Staff Report Presented to the Planning Commission - REVISED

REQUEST: The applicant is requesting to subdivide an approximately 282,704 square foot (6.49 acre) property into 29 residential lots, 1 storm detention lot and associated roadway and utility improvements. The subject property is to the east of 23rd Avenue and west of 27th Avenue and is identified by Linn County Tax Assessor’s Map No. 13S01E32CA Tax Lot 4403. Lot sizes would range in size from 7,206 square feet to 8,626 square feet. All lots would be eligible to be developed with single, family dwellings *and/or duplexes* [SHMC 17.10.020(A and B)]. The subject property is in the Residential Low Density (R-1) Zone.

FILE NUMBER: SD24-01

Sheet **C102**
 SCALE: SEE BARSCALE

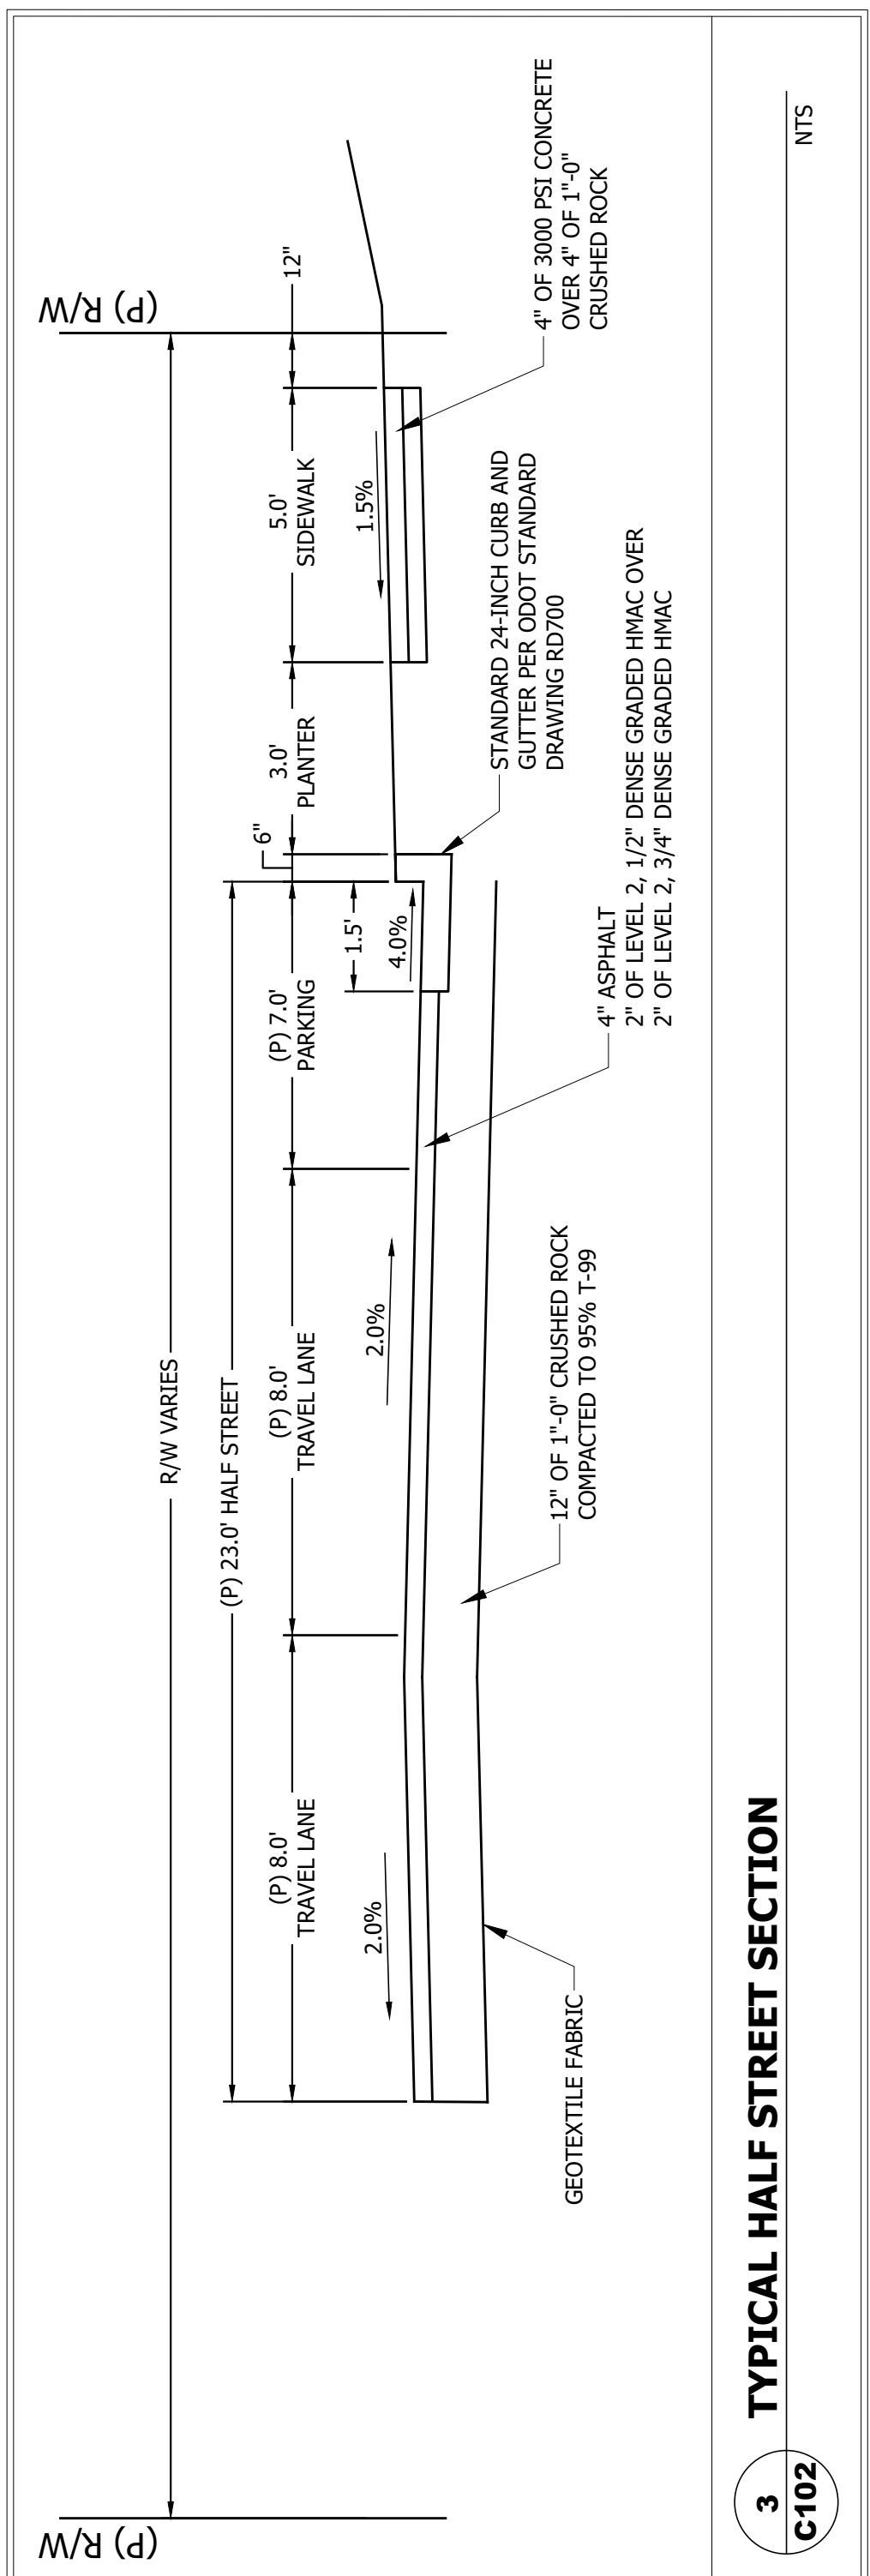
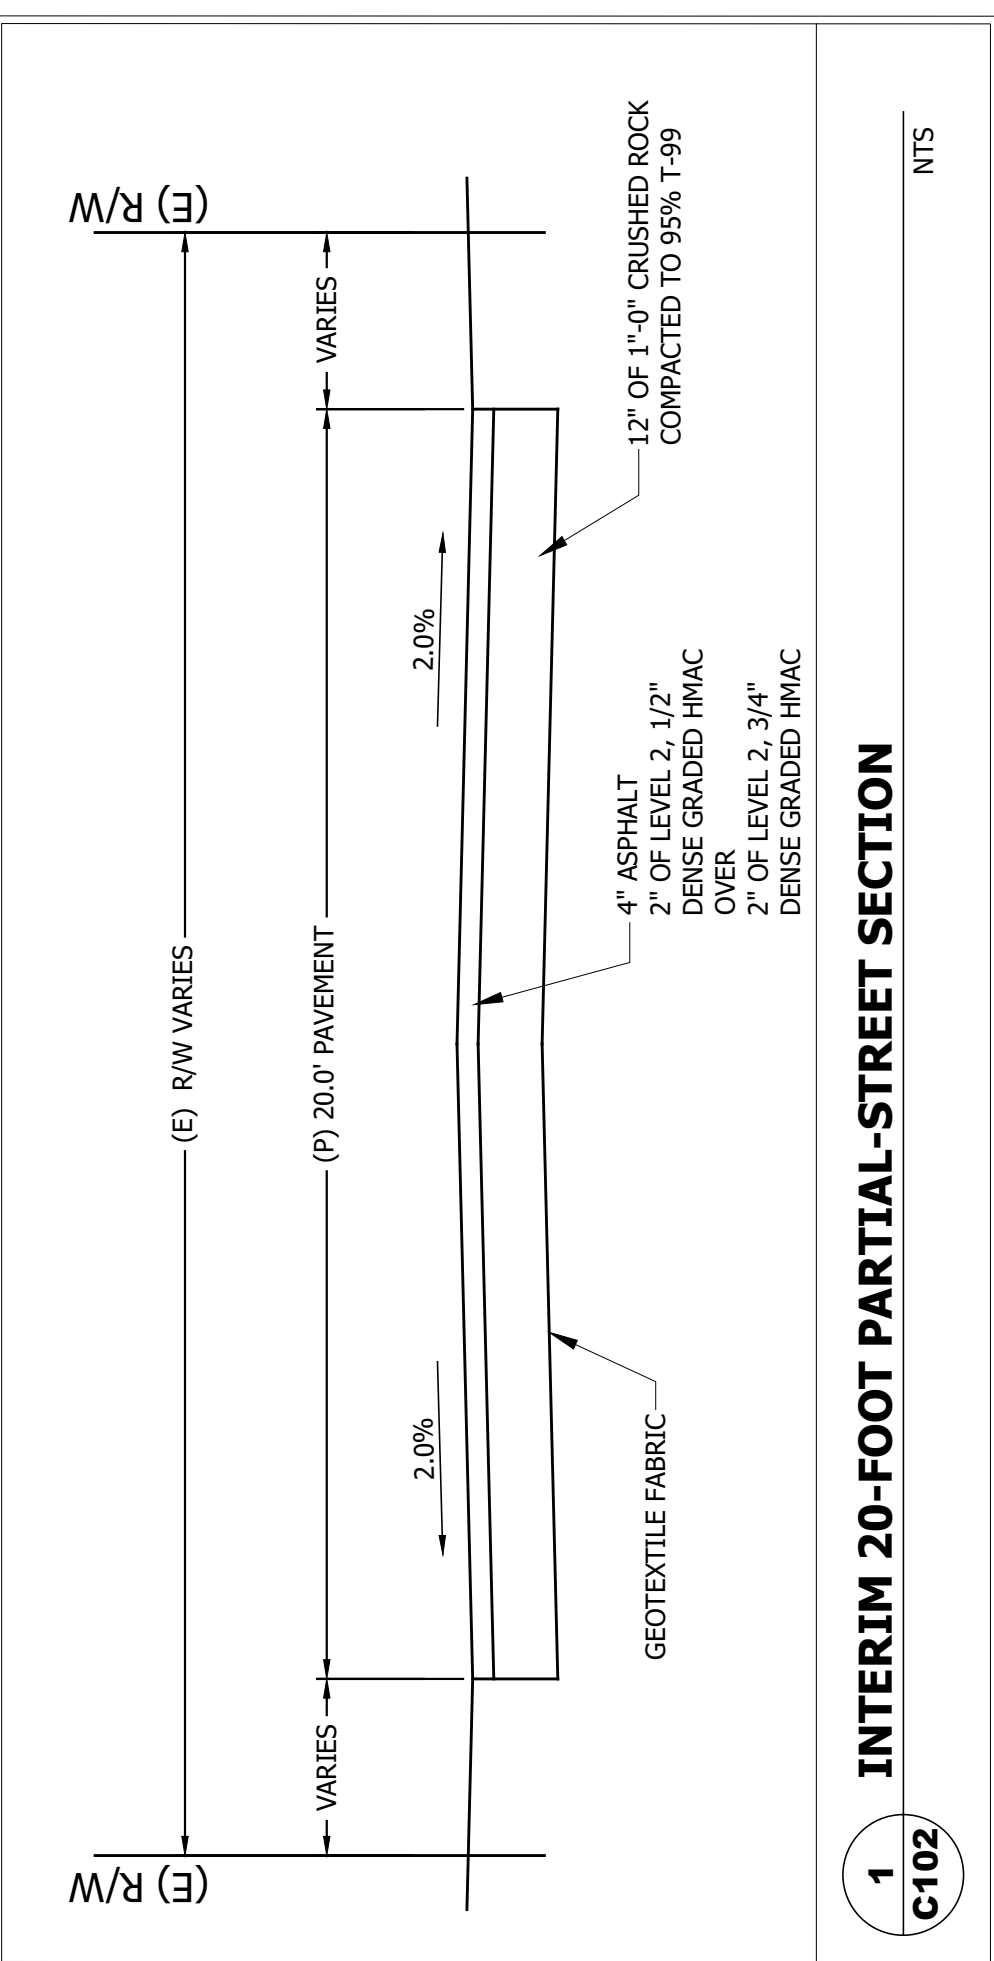
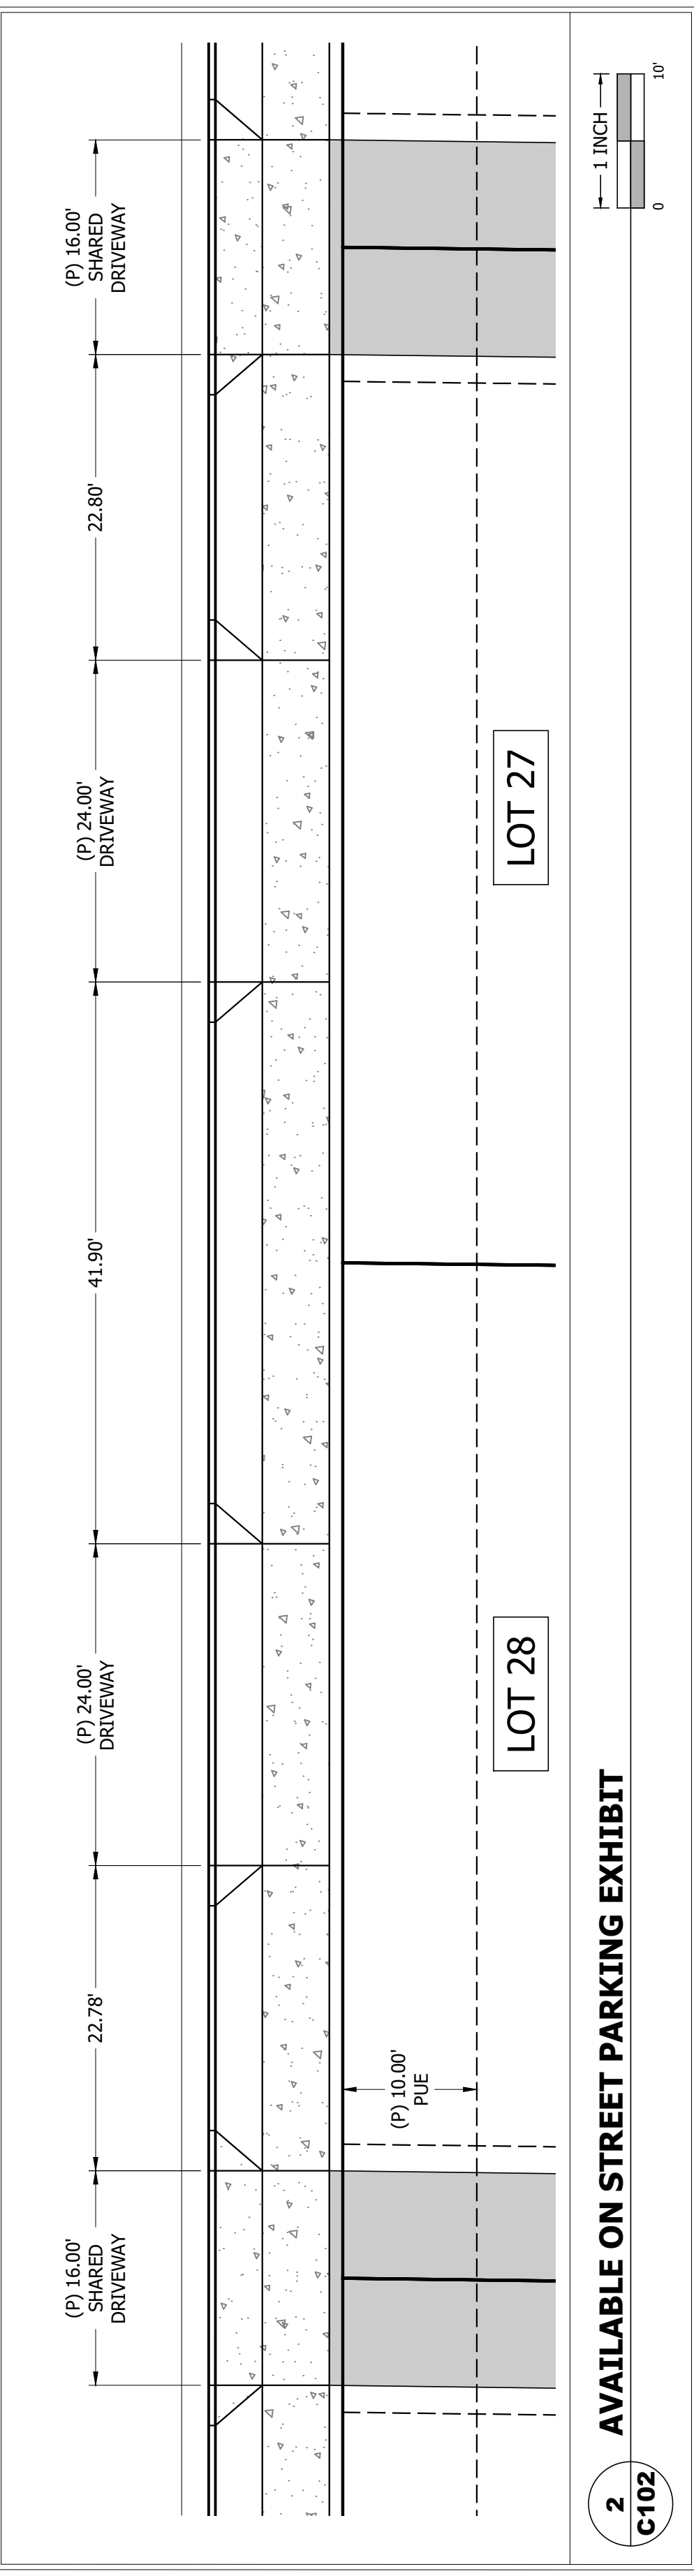
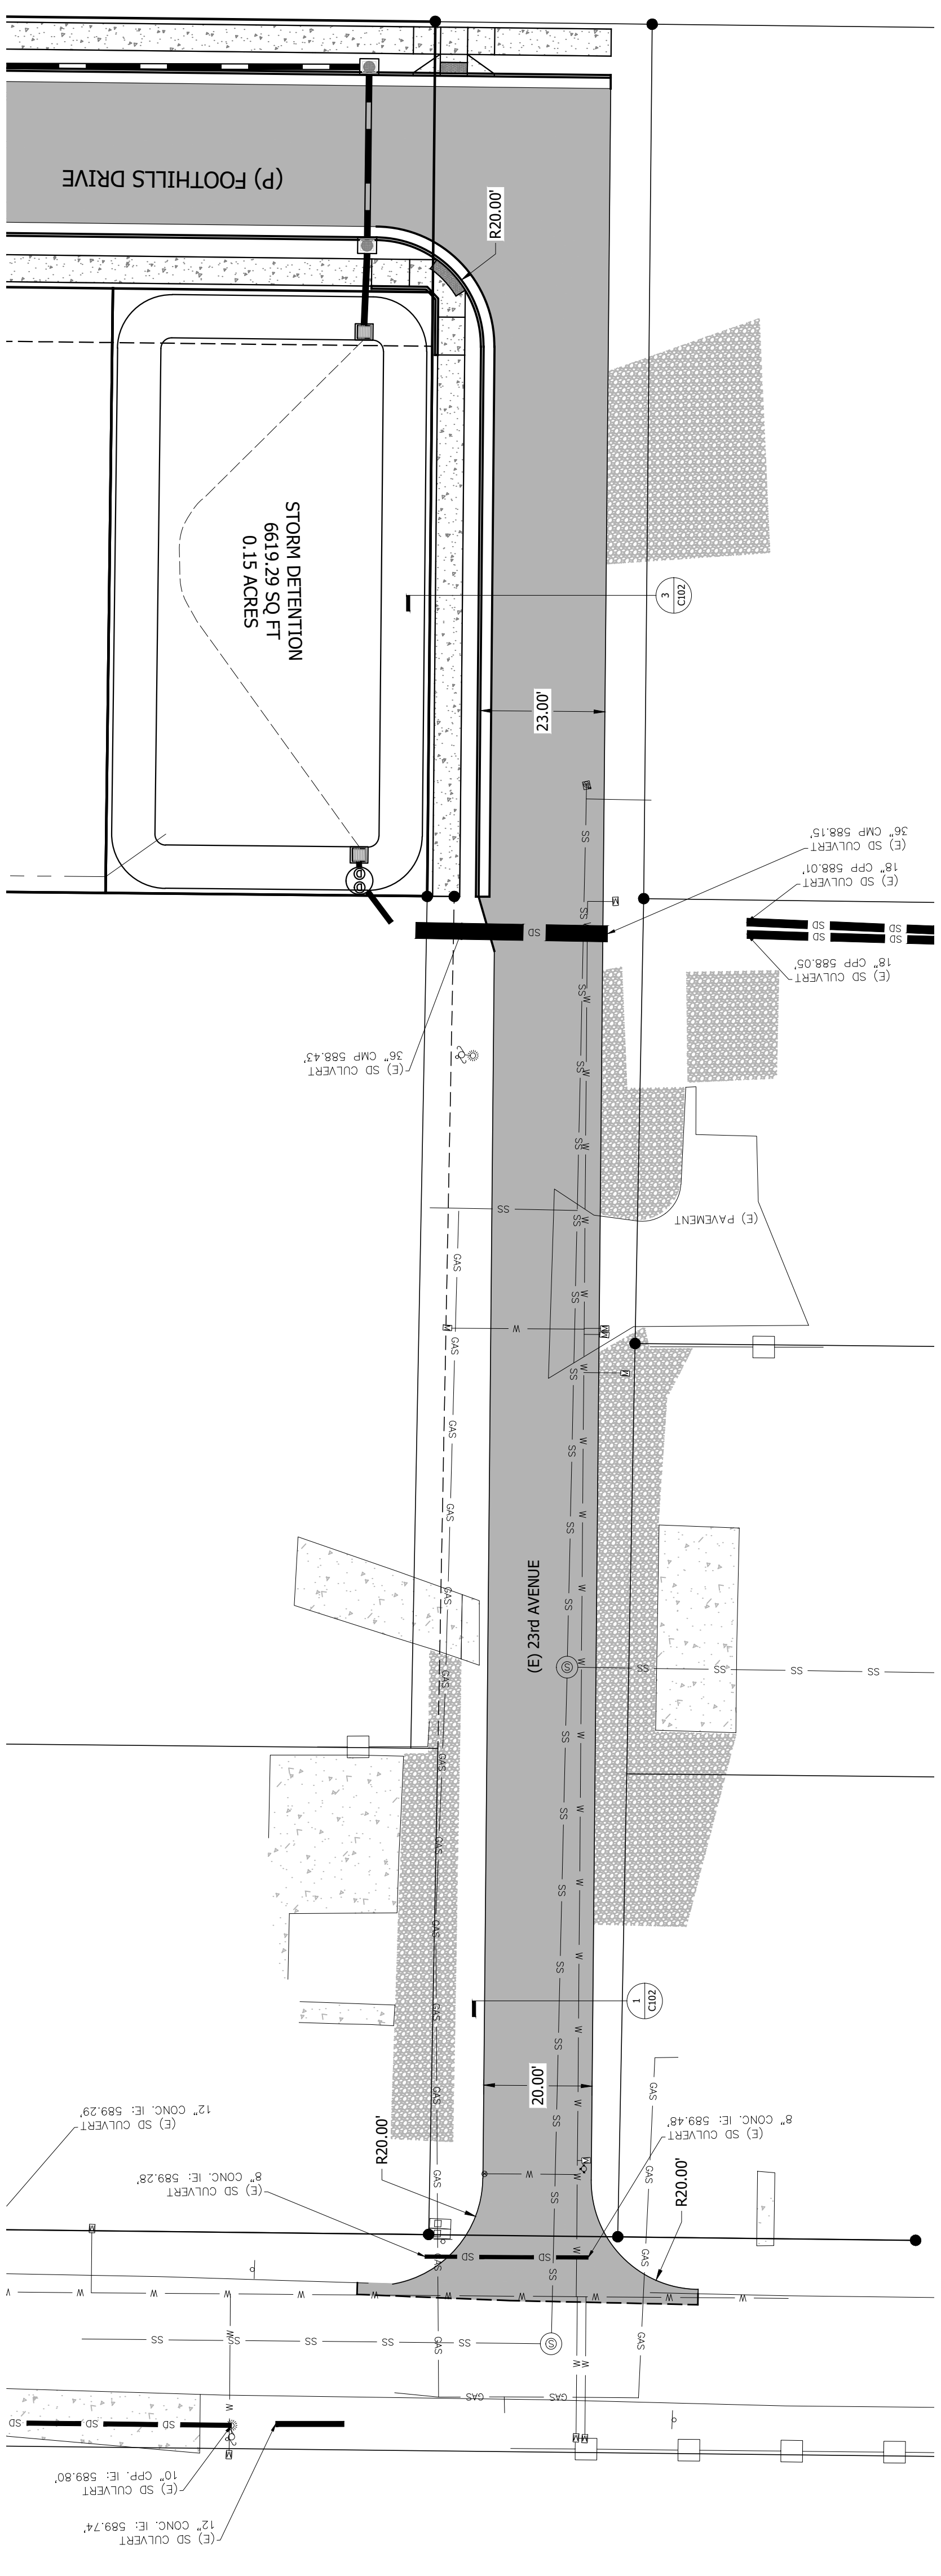
SHMC 17.42.040 requires a minimum 3-foot planter strip for Local Streets which the narrative and plan do not show. Foothills Drive is wide enough for planter strips to be constructed and are required. The proposal shows a 50-foot right-of-way, which provides adequate width on each side for 5-foot sidewalk, 3-foot planter, and a 6 inch curb which provides the minimum 7ft parking and travel lanes, etc.
